RE: **Lot 2 Block 3 Unit 18, S.A.D. 228  
Volcano Cliffs Subdivision  
6612 Cuervo Pl. NW  
Grading and Drainage Plan  
Engineers Stamp Date 10/28/19 (D10D003S2)**

Based upon the information provided in your submittal received 10/29/19, this plan is approved for Grading Permit.

JOHNSON (MIKE SANCHEZ) - 6612 CUERVO GRADING & DRAINAGE PLAN

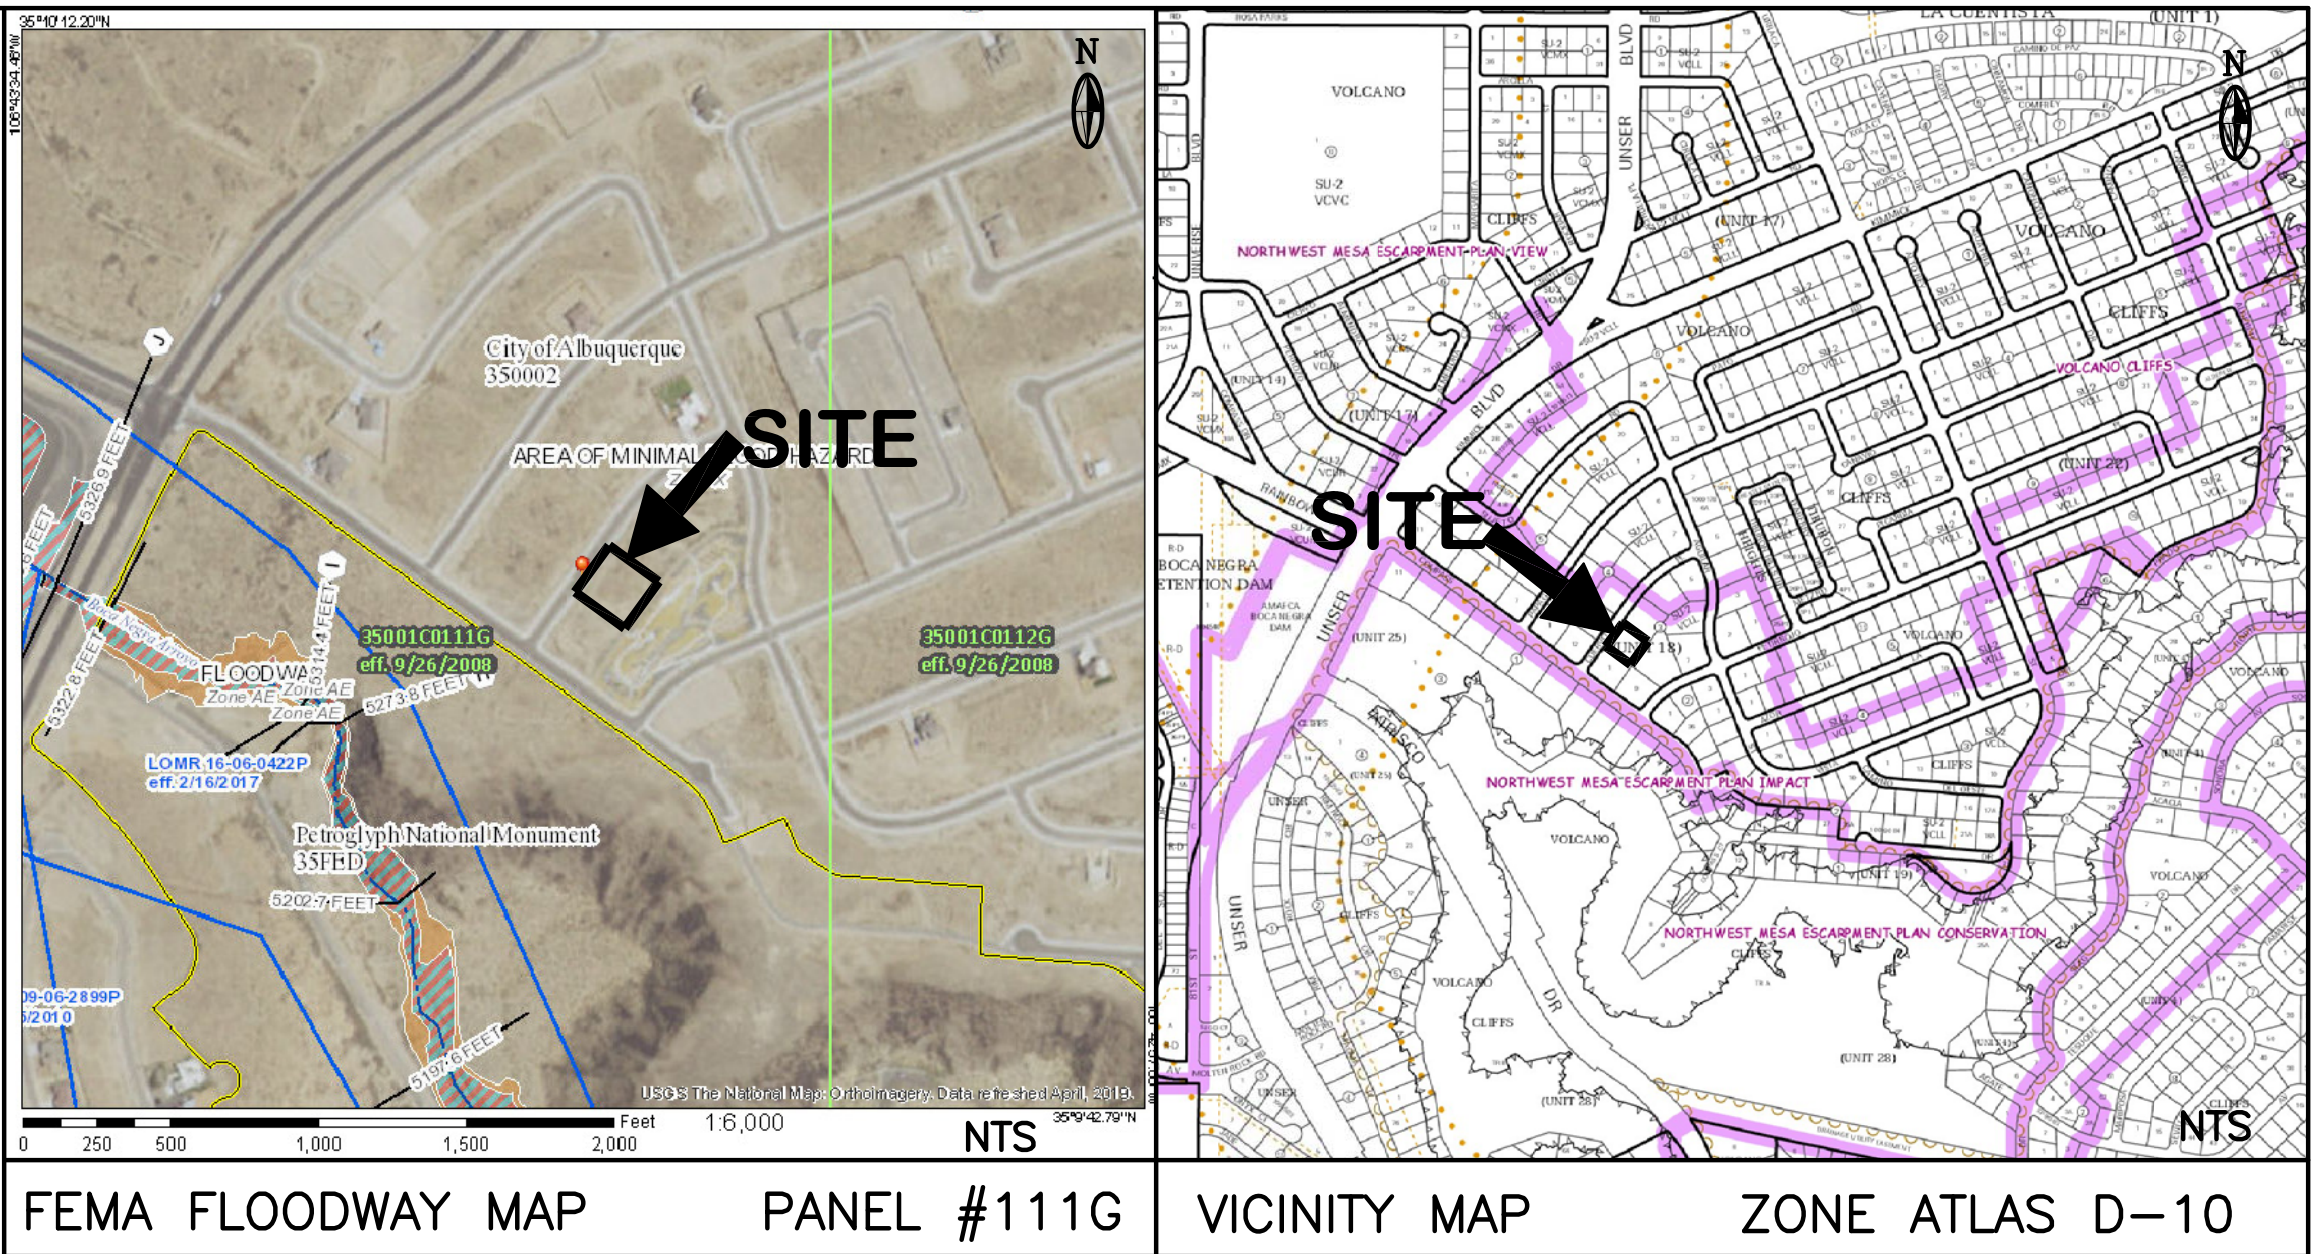
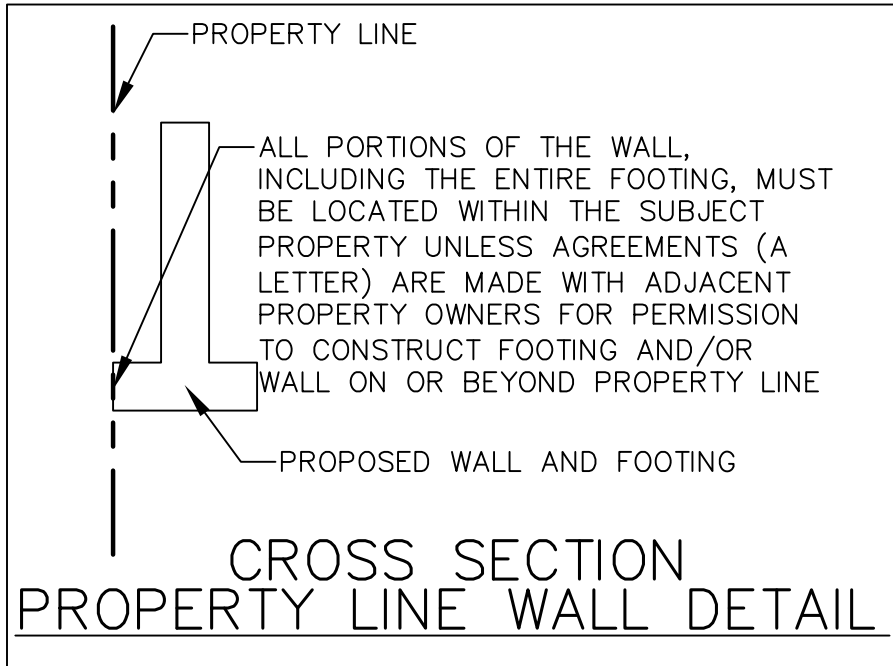
**Prior to Building permit approval a Pad Certification will be required, provided by the Engineer or a registered Land Surveyor.**

Reiterate to the Owner/Contractor that a separate permit for a garden/retaining wall must be obtained, with the approved G&D plan dated 10/28/19.

Prior to Certificate of Occupancy release, Engineer Certification per the DPM checklist of this plan will be required.
